Addendum No. 1

Project: Francis Marion University
Deferred Maintenance – McNair and Leatherman Roofs
4822 E Palmetto Street
Florence, SC 29506

WMBE Project Number: 2024-81

Questions and Answers

R-1.5

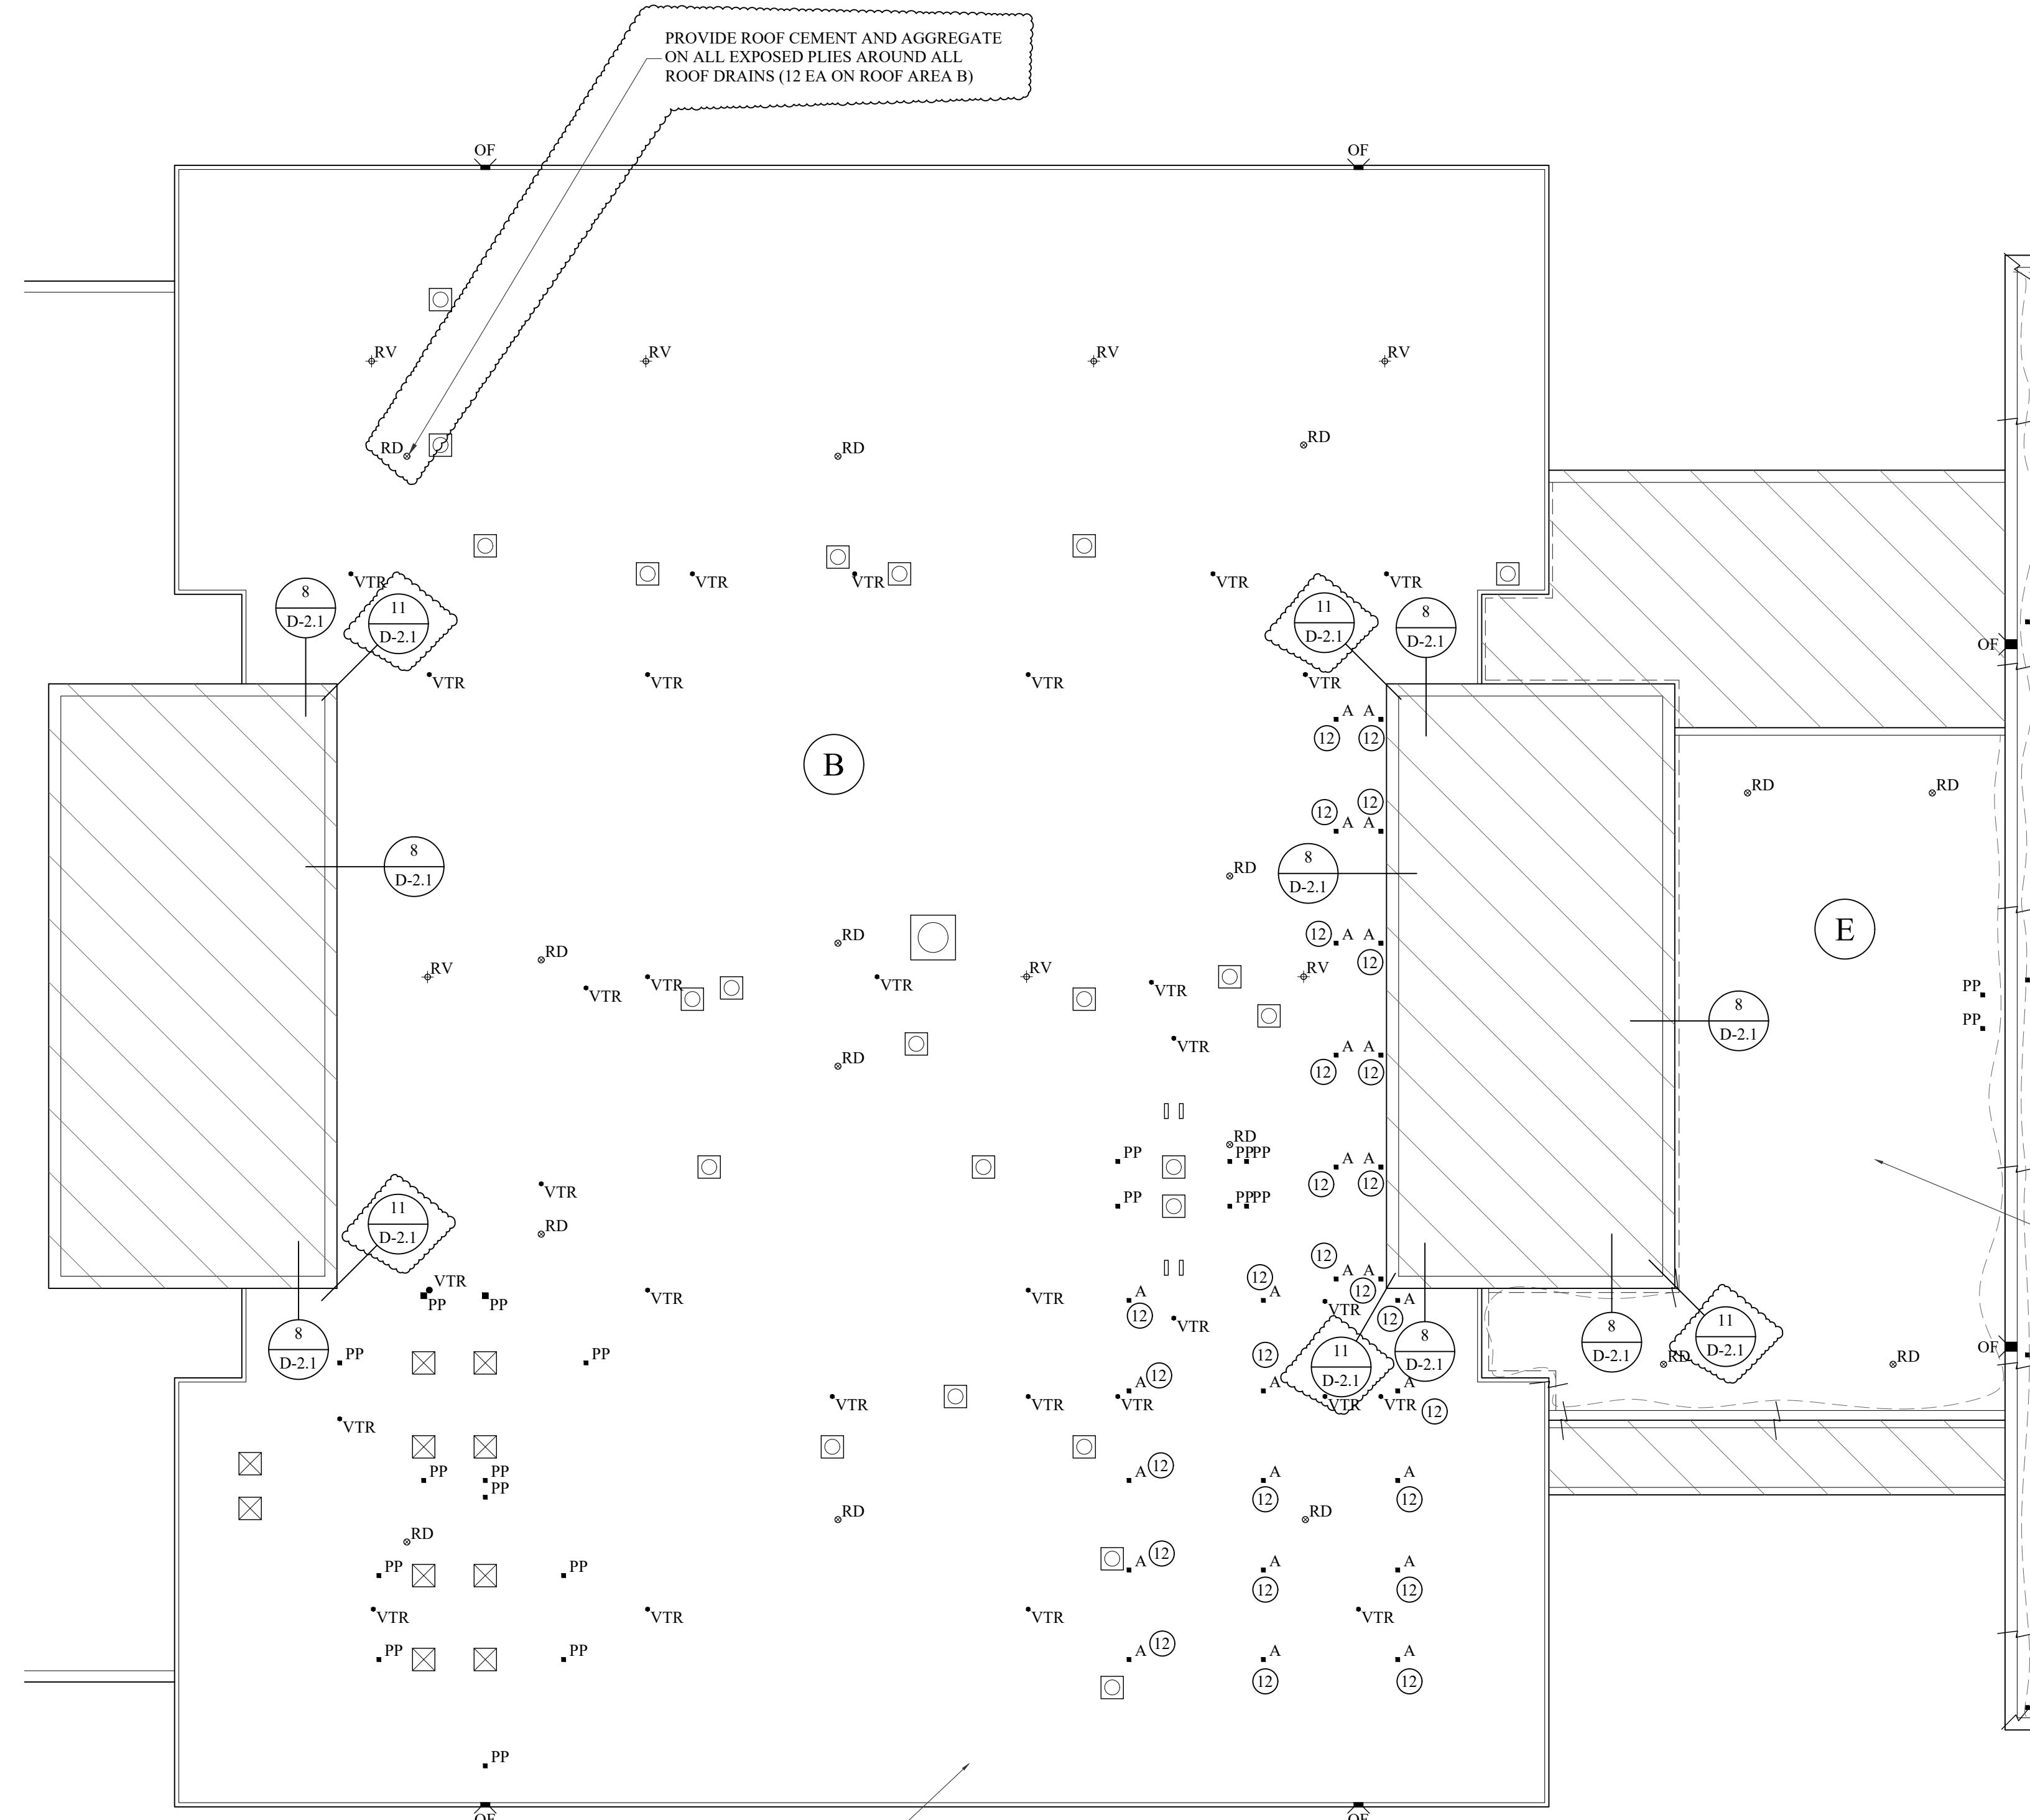
Alternate No. 01 includes the removal of the existing planter trays, planter materials, protection membrane, sprinkler systems, electrical, etc. from the roof system at Leatherman Science Facility. Roof repairs to the existing roof system, flashings, wall systems, etc. are also included as noted on Roof Repair Plan (Alternate No. 1) on Sheet R-1.5.

- A. **Answer:** Please see attached updated R-1.6 with additional repair locations.
12. **Question:** Just wanted to confirm that Alternate 1 is to include the removal of planter trays and related materials and the repairs as marked with the numbers detailed on drawing R1.5? The bid form just states the removal of existing planter trays and related materials without and does not refer to the repairs.

R-1.6

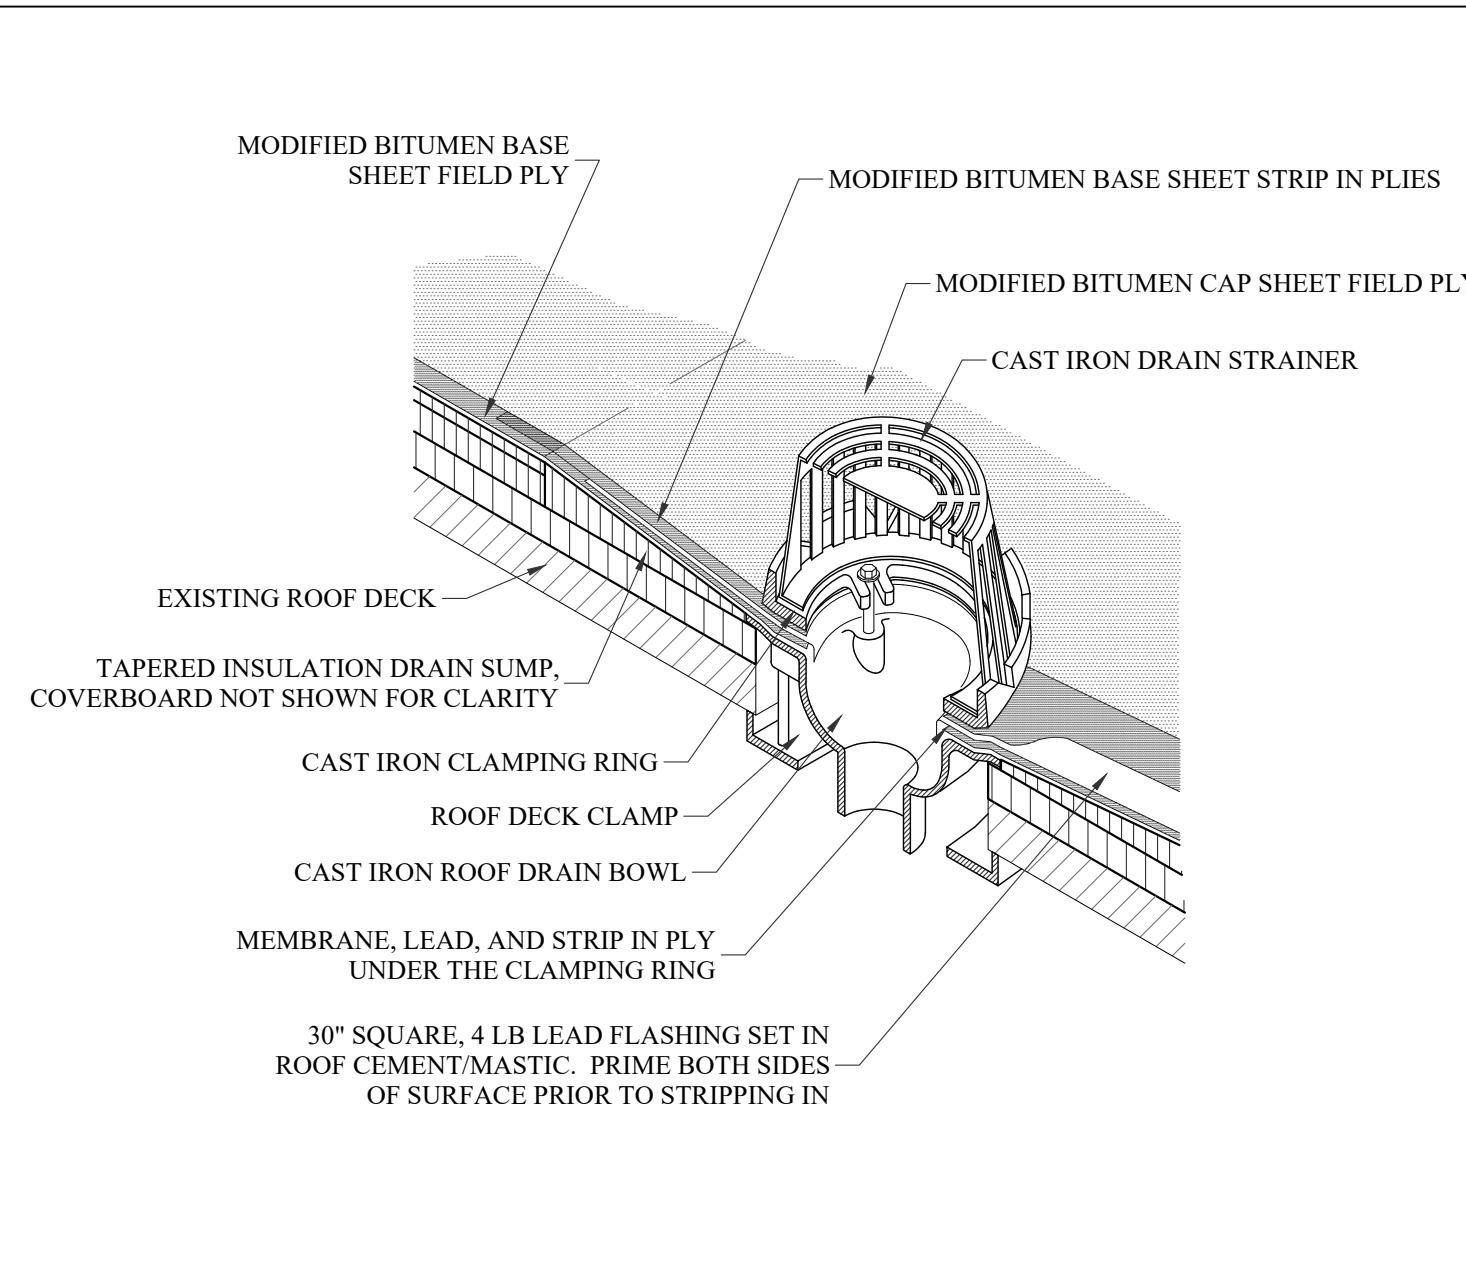
Alternate No. 02 includes select roof repairs at areas not being replaced at McNair Science Building. Roof repairs to the existing roof system, flashings, wall systems, etc. are also included as noted on Roof Repair Plan (Alternate No. 2) on Sheet R-1.6.

11. **Question:** Just wanted to confirm that for Alternate 2 as shown on drawing R1.6, we are only figuring the removal of abandoned penetrations and patch the roof system at locations with marked with #12 and installing flush mounted wall panels with flashing and trim at the brick walls of the stairwells/penthouses?

6 BASE FLASHING AT CURTAIN WALL
D-1.1 N.T.S.

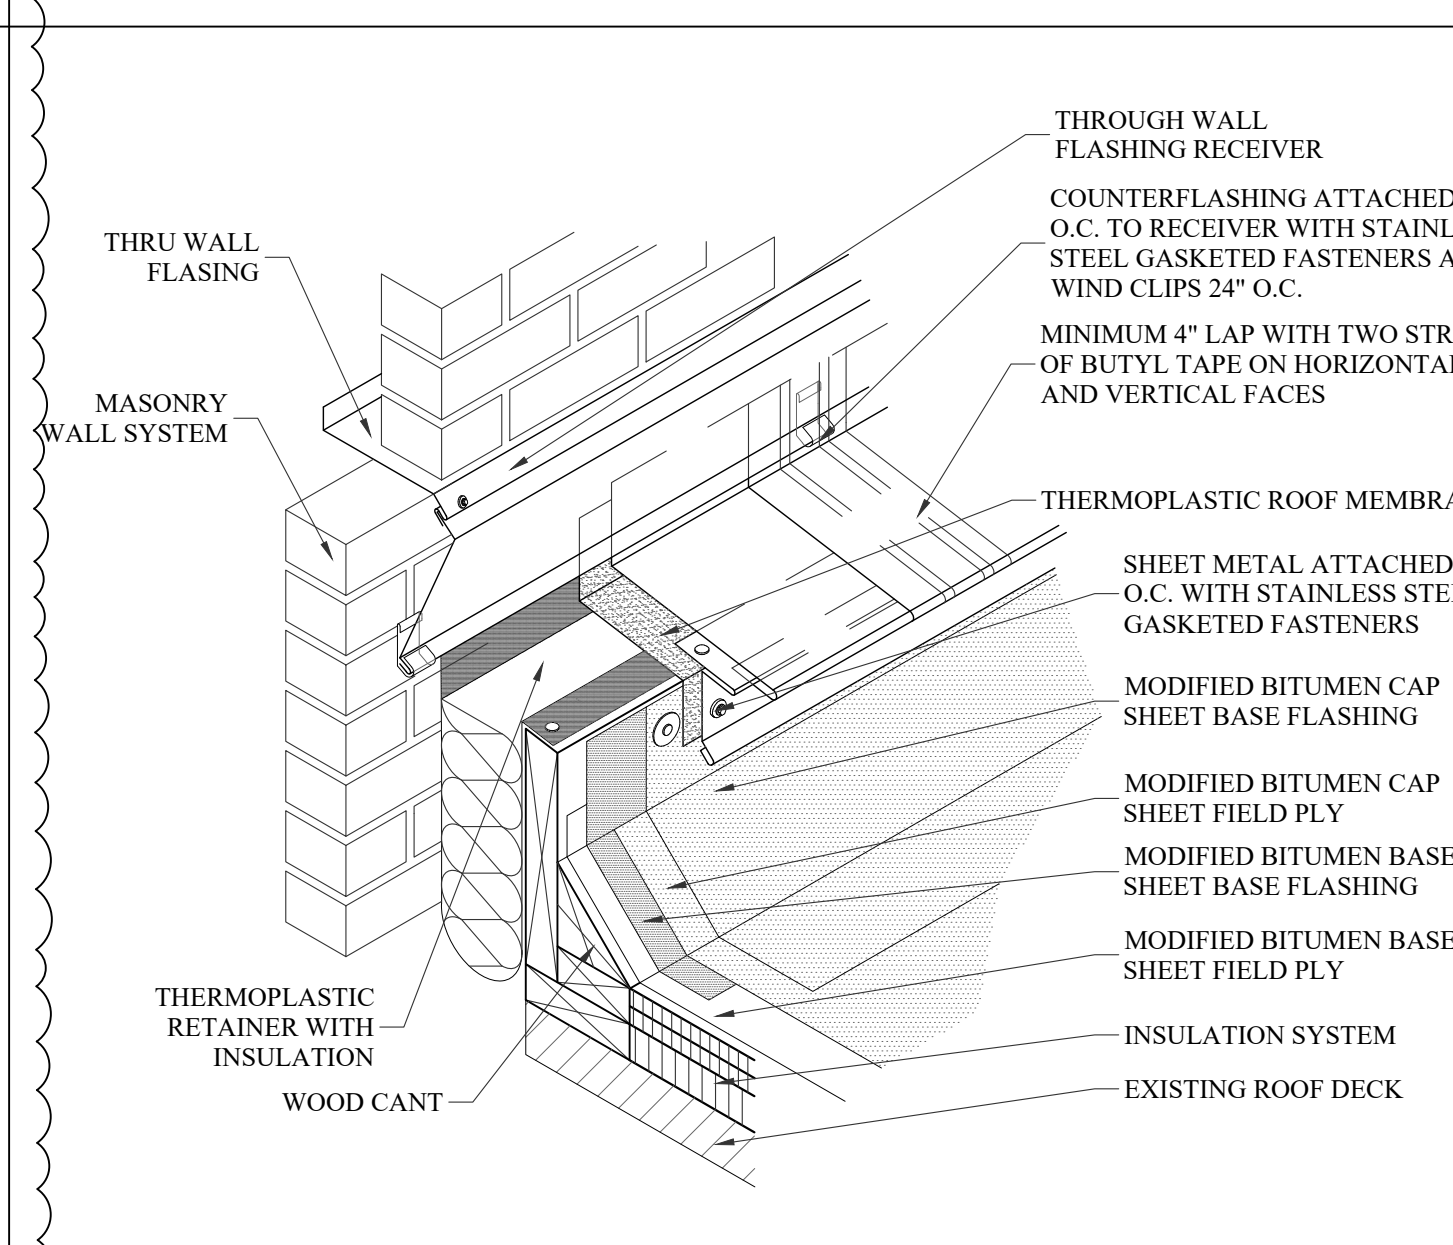
- A. **Answer:** These are the approximate locations of thermal anomalies during the infrared scan performed.
7. **Question:** Can you please clarify the base flashing detail to be provided at the base of the curtain wall?

- A. **Answer:** The existing counterflashing is surface mounted. The new base flashing shall be provided with 3 course mastic and fabric provided over the top of the base flashing. The counterflashing shall be surface mounted, similar to existing, and/or extending under existing counterflashing at the base of the curtain wall.
